A1 Birtley to Coal House

Scheme Number: TR010031

Summary of Proposed Changes to Application January 2020

**The A1 Birtley to Coal House
Development Consent Order 20[xx]**

Drawing 2 – Illustrative elevation of 3-span viaduct design

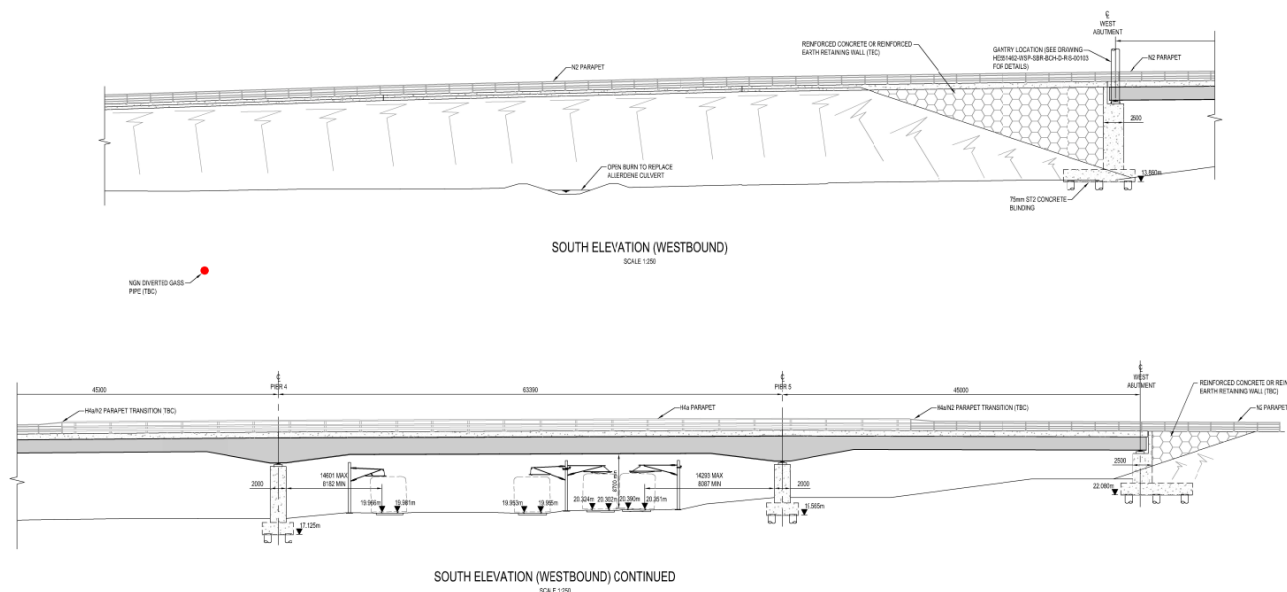
- 2.1.1 The Applicant proposes to amend the Application to enable a 3-span viaduct with reinforced embankments to be constructed to provide the new alignment for the A1 over the East Coast Main Line and replacement for Allerdene Railway Bridge. It is proposed that this option should be provided for within the Application in addition to the single span integral bridge and 6/7 span viaduct that are currently provided for within the DCO and other application documents.

- 2.1.2 The 3-span viaduct proposal would comprise a central span (of approx. 65m in length), which would pass over the railway, with back spans to the east and west of the railway (each approx. 45m in length). The form of the superstructure would be a composite deck comprising a reinforced concrete deck slab atop steel girders as for the other options. This form is unchanged from the DCO application design.

- 2.1.3 It is also proposed that reinforced soil is used to form the approach embankments to the east and west of the railway. This would result in slopes being steepened to a suggested maximum angle of 60 degrees (from the current 1 (vertical) in 3 (horizontal) slope within the DCO application).

2.1.9 The alignment of the proposed structure will be unchanged. The footprint would change so as to reflect the division between embankment and bridge/viaduct, and the embankment would also be altered as a result of the steepening of its slopes as described at paragraph 2.1.3 above. The culvert which carries Allerdene Burn will appear as shown on Sheet 3 of the Structures Engineering Drawings and Sections (**Application Document Reference. TR010031/APP/2.7**)

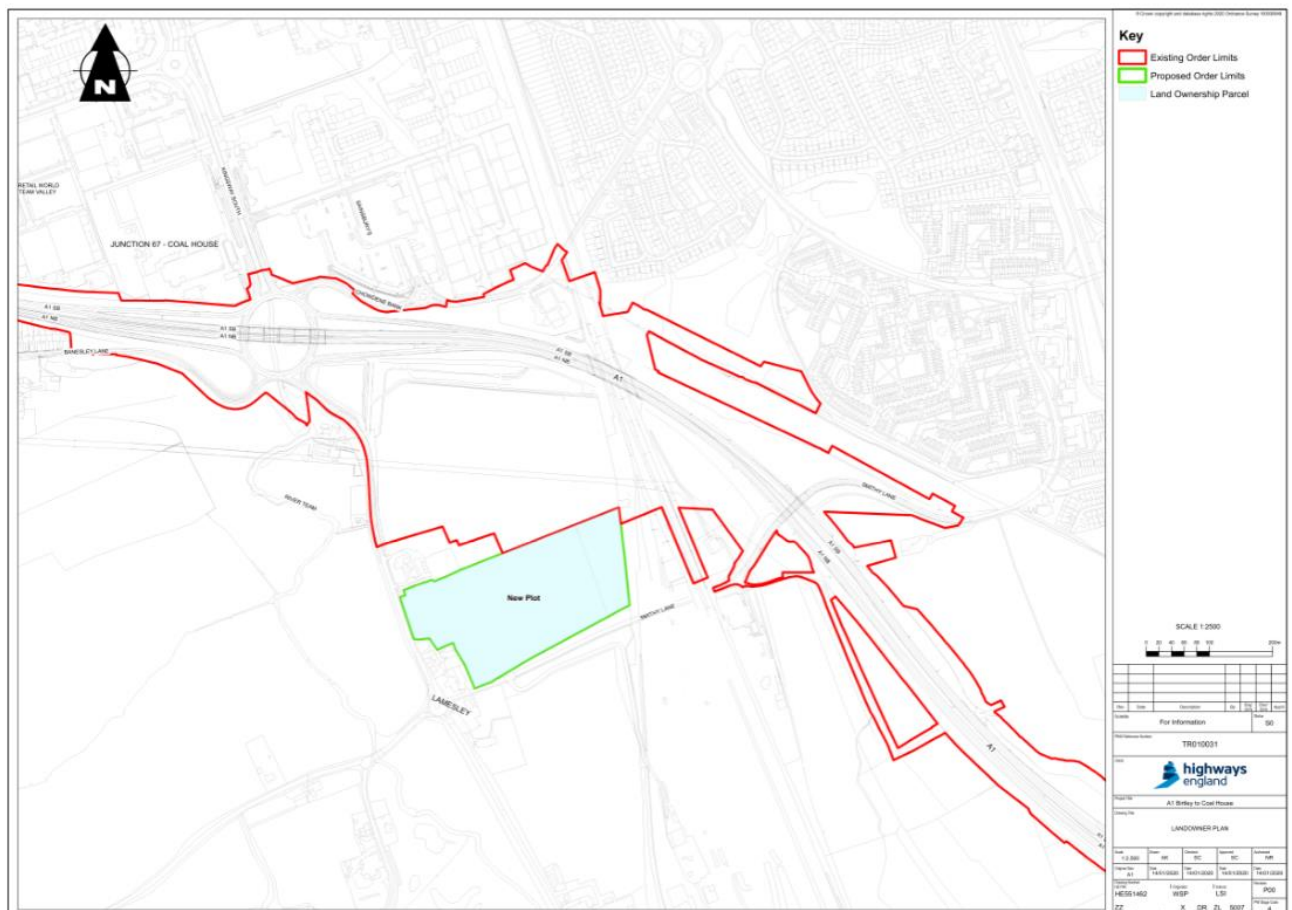
- 2.1.26 The Applicant is proposing to seek temporary possession powers over additional land to accommodate a temporary material stockpile during construction of the Scheme. This provision will enable the appointed delivery partner, which will construct the Scheme, to optimise the programme for construction of the proposed earth embankment for the new Allerdene Bridge to the west of the East Coast Mainline.

- 2.1.29 However, a plot of land of sufficient size to accommodate an optimized material stockpile has been identified adjacent to the existing site compound at junction 67 and adjoining the current Order limits to the south of plot 3/6c ("additional plot"). The additional plot is approximately 5 hectares in area and would be able to accommodate the stockpiled material. Alongside this a temporary construction access road would be required for access to this additional plot from the current proposed site compound area and a wheel wash facility and temporary water management control would be required for the import of fill material by road.

2.1.32 The drawing below shows the location of the additional plot and its relationship to the Scheme.
